Access Compliance Report
Public Rights-of-Way
(Curb Ramps)

Intersection ID: 11457 **Main Street:** TRYON-CHURCH_CONNECTOR_ST **Cross Street:** N_CHURCH_ST **Location:** E

ADA ID: 6BF752BDA274 **Ramp Type:** Para **Initial Pass/Fail:** Fail **Overall Compliance:** No **Severity Score:** 12.5

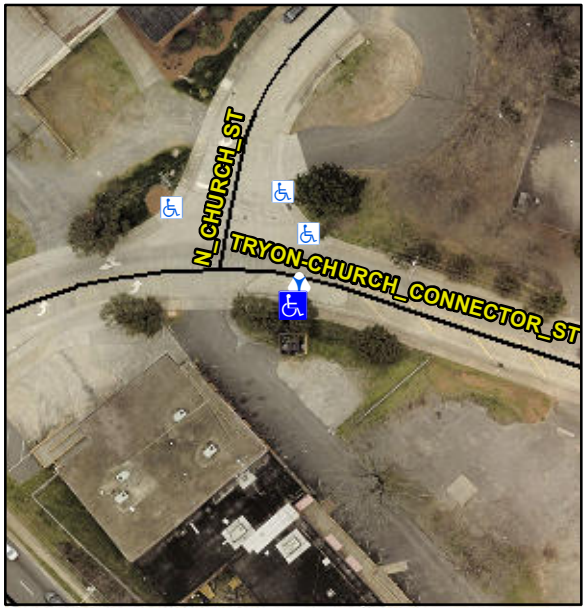
Codes/Mitigation Info/Possible Solution

PROW/ADA:

R304.5.3

Compliance	Description	Data	Compliance	Description	Data
N/A	Ramp Length LT (in)	70.0	N/A	Ramp Length RT (in)	70.5
Yes	Ramp Width LT (in)	60.0	Yes	Ramp Width RT (in)	59.5
Yes	Ramp Slope LT (%)	5.0	Yes	Ramp Slope RT (%)	6.8
No	Ramp XSlope LT (%)	2.3	No	Ramp XSlope RT (%)	6.0
N/A	Landing Length (in)	N/A	N/A	DWS Provided?	N/A
N/A	Landing Width (in)	N/A	N/A	DWS Contrast?	N/A
N/A	Landing Slope (%)	N/A	N/A	DWS Length (in)	N/A
N/A	Landing X Slope (%)	N/A	N/A	DWS Full Width?	N/A
N/A	Landing Curb? (Y/N)	N/A	N/A	DWS Offset (in)	N/A
N/A	Shared Landing?	N/A			
N/A	Gutter Ponding?	N/A	N/A	Gutter Slope (%)	N/A
N/A	Gutter Lip Ht (in)	N/A	N/A	Gutter X Slope (%)	N/A
N/A	Painted X Walk1?	No	N/A	Painted X Walk2?	N/A
	X Walk 1 Direction	To N		X Walk 2 Direction	N/A
N/A	X Walk 1 Width (in)	N/A	N/A	X Walk 2 Width (in)	N/A
	X Walk 1 Slope (%)	6.2		X Walk 2 Slope (%)	N/A
	X Walk 1 X Slope (%)	1.3		X Walk 2 X Slope (%)	N/A
N/A	Ramp inside XWalk1?	N/A	N/A	Ramp inside XWalk2?	N/A

Possible Solutions:

Remove & Replace Entire Ramp.
